PALO VERDE NUCLEAR GENERATING STATION, UNIT NO. 1

AMENDMENT TO FACILITY OPERATING LICENSE

Amendment No. 52
License No. NPF-41

ENCLOSURE TO LICENSE AMENDMENT

FIGURE 3.4-2a
 REACTOR COOLANT SYSTEM PRESSURE/TEMPERATURE
 LIMITATIONS FOR LESS THAN 8 EFFECTIVE
 FULL POWER YEARS OF OPERATION

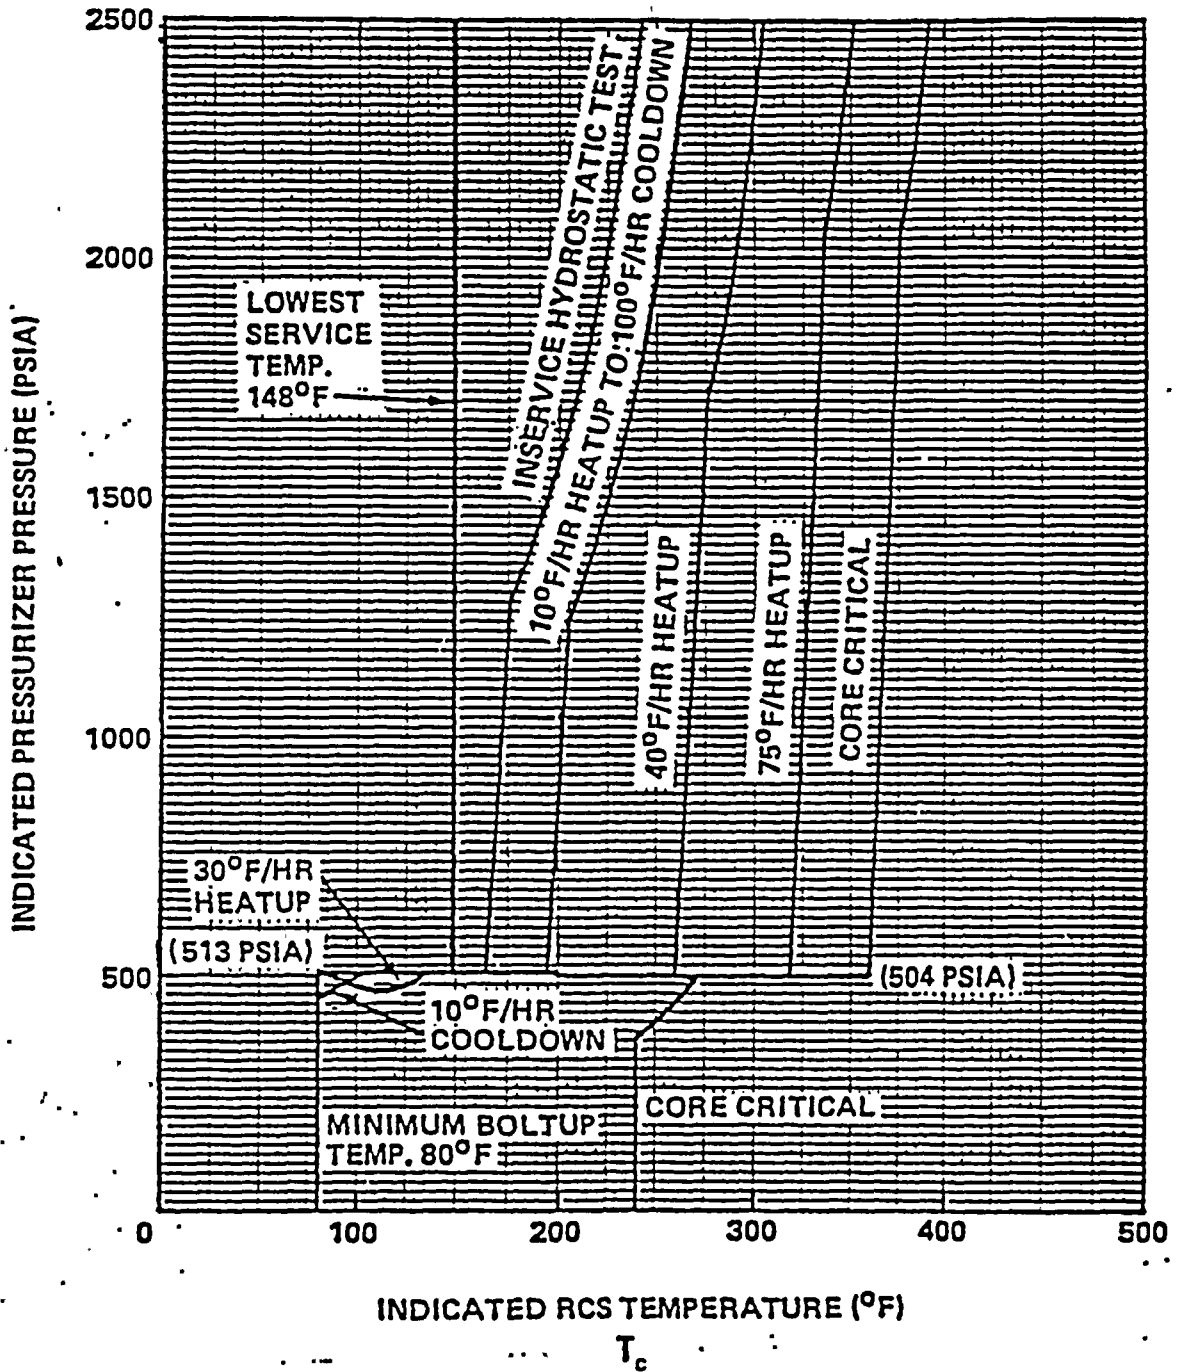
3.4.8.1 The Reactor Coolant System (except the pressurizer) temperature and pressure shall be limited in accordance with the limit lines shown on Figures 3.4-2a or 3.4-2b during heatup, cooldown, criticality, and inservice leak and hydrostatic testing with:

The pressure-temperature limit lines shown on Figures 3.4-2a and 3.4-2b for criticality and for inservice leak and hydrostatic testing have been provided to assure compliance with the minimum temperature requirements of Appendix G to 10 CFR Part 50. The reactor vessel material irradiation surveillance specimens are removed and examined to determine changes in material properties. The results of these examinations shall be used to update Figures 3.4-2a and 3.4-2b based on the greater of the following:
